CALLAWAY PLANT
DOCKET NUMBER 50-483
CORE OPERATING LIMITS REPORT
Reference: ULNRC-04145, dated November 4, 1999

CALLAWAY CYCLE 11

CORE OPERATING LIMITS REPORT

(Revision 2)

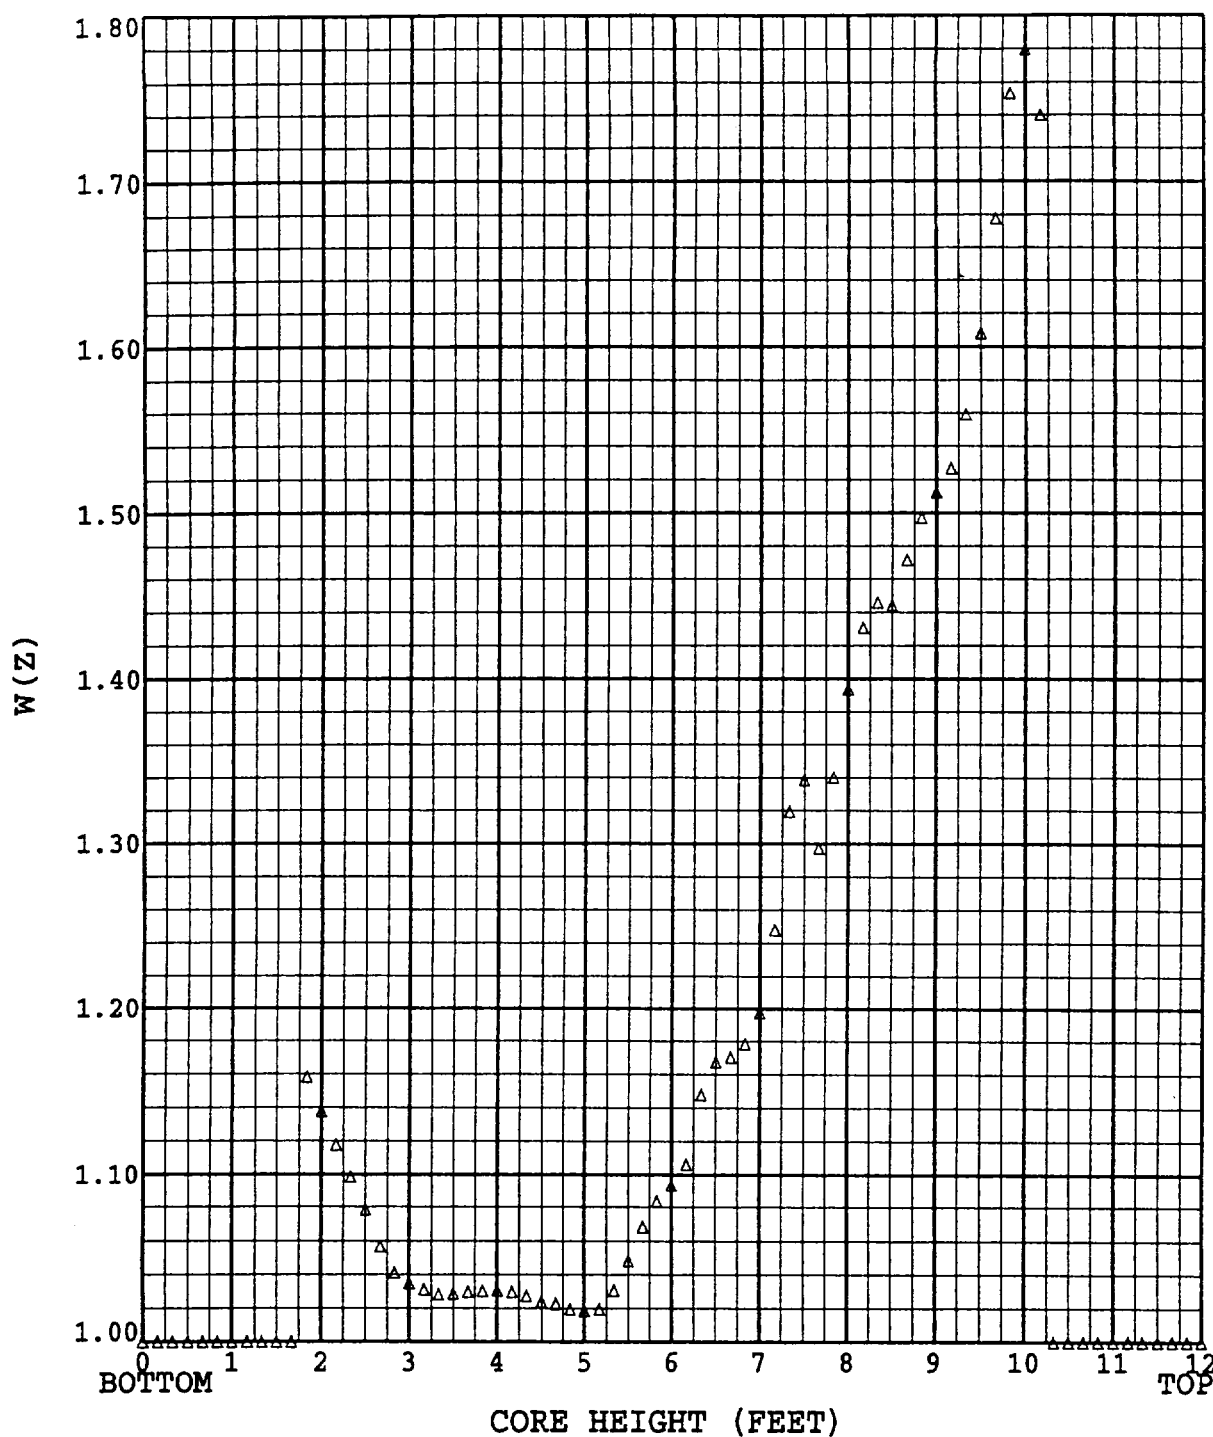
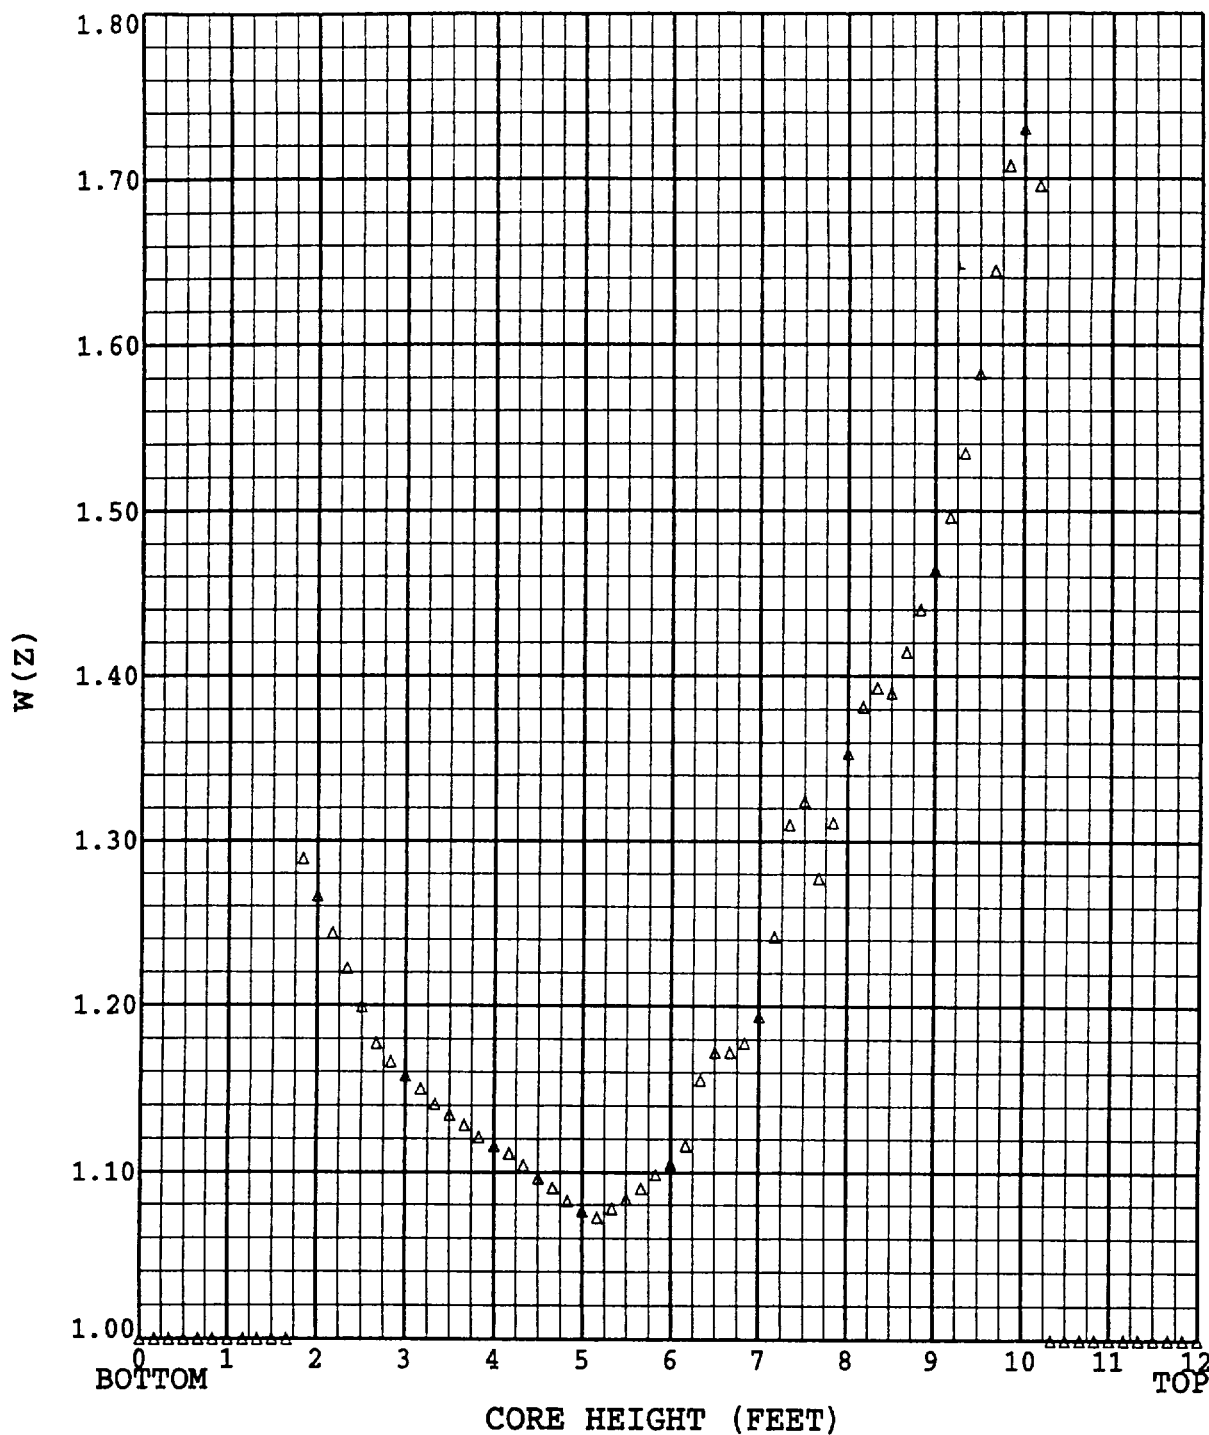
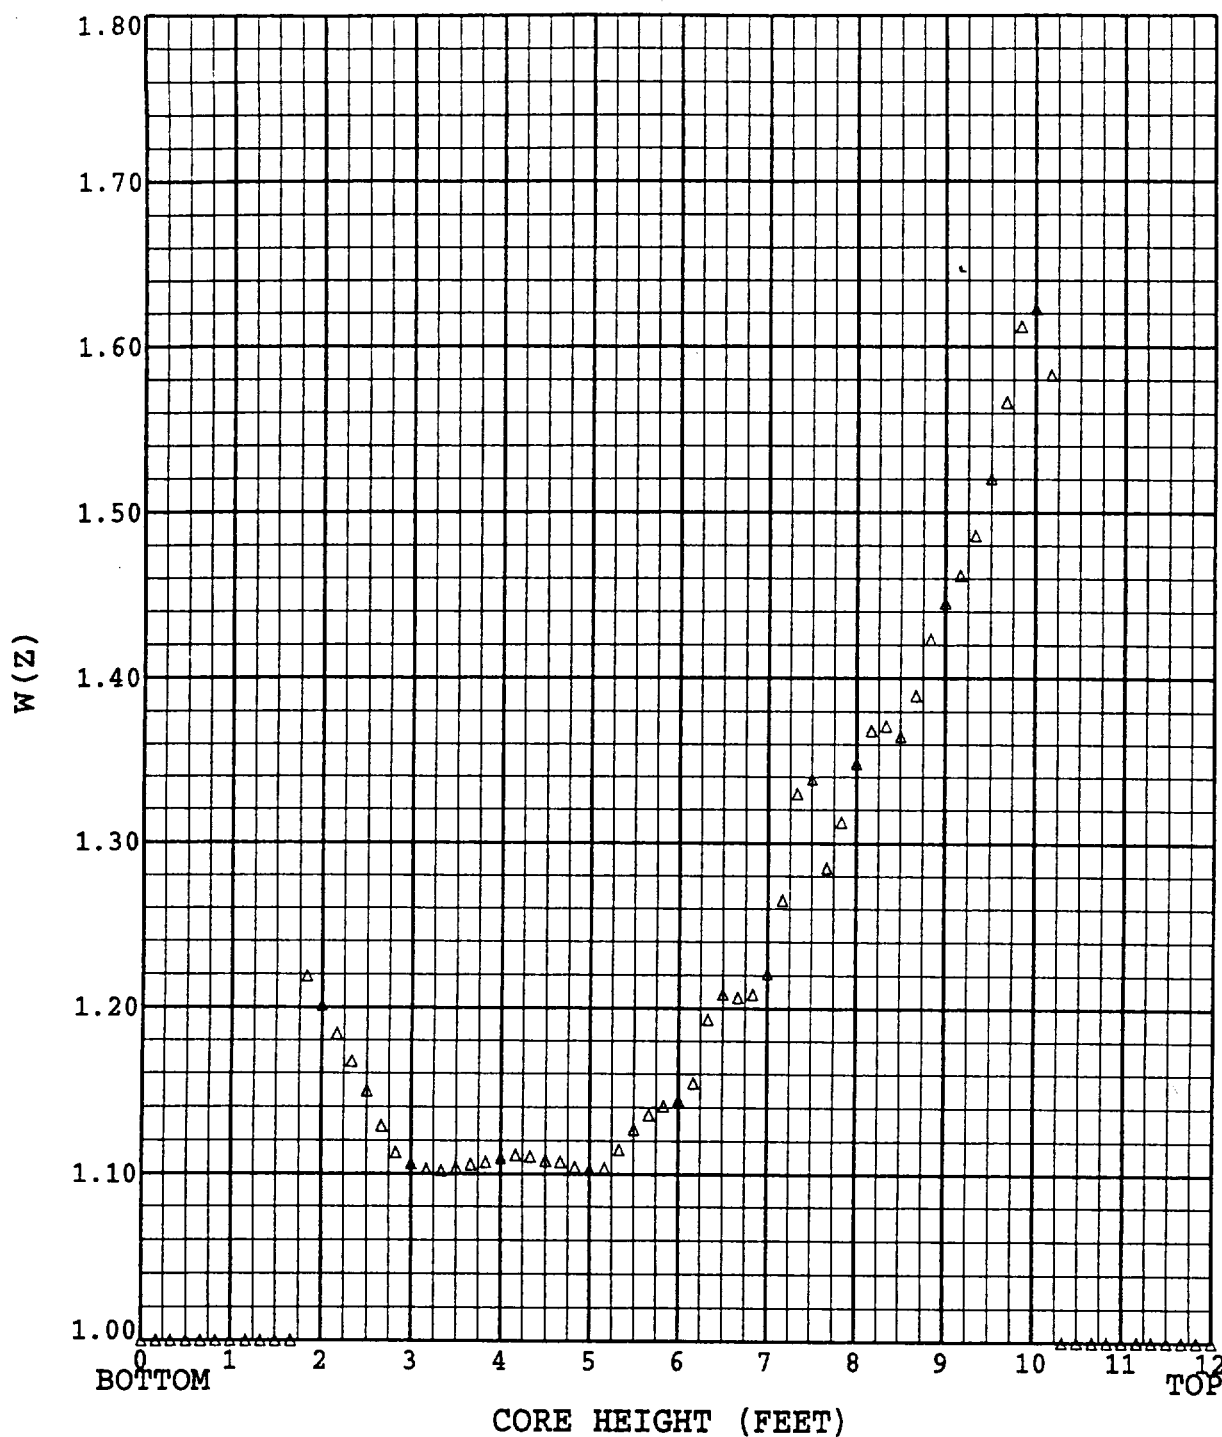
In Revision 2, the COLR has been revised in order to provide additional W(z) values. Figures 9 through 12, and Figures 13 through 16, are applicable to measured axial offsets within $\pm 3\%$ of (measured - predicted) axial offset differences of -3.9% and -9.0% , respectively. In addition, the F_Q^{RTP} limit of 2.45 for Cycle 11 is increased to 2.50 for core average burnups of 8000 MWD/MTU and greater. Revision 2 incorporates Revision 1.

$W(z)$ values have also been determined for a range of measured axial offset values for Cycle 11. For measured axial offset values within $\pm 3\%$ of the predicted axial offset value, Figures 4 through 8 are applicable. Additional $W(z)$ values are provided in Figures 9 through 12 applicable to measured axial offsets within $\pm 3\%$ of a [measured – predicted] axial offset difference of -3.9% . Figures 13 through 16 provide $W(z)$ values applicable to measured axial offsets within $\pm 3\%$ of a [measured – predicted] axial offset difference of -9.0% . For purposes of burnup interpolation, a consistent set of $W(z)$ values should be used based on the difference between measured and predicted axial offset. The $W(z)$ set selected could be either the set closest to the actual [measured – predicted] axial offset difference, or a consistent set derived by linear interpolation on the [measured – predicted] axial offset differences between two of the $W(z)$ sets closest to the actual [measured – predicted] axial offset difference.
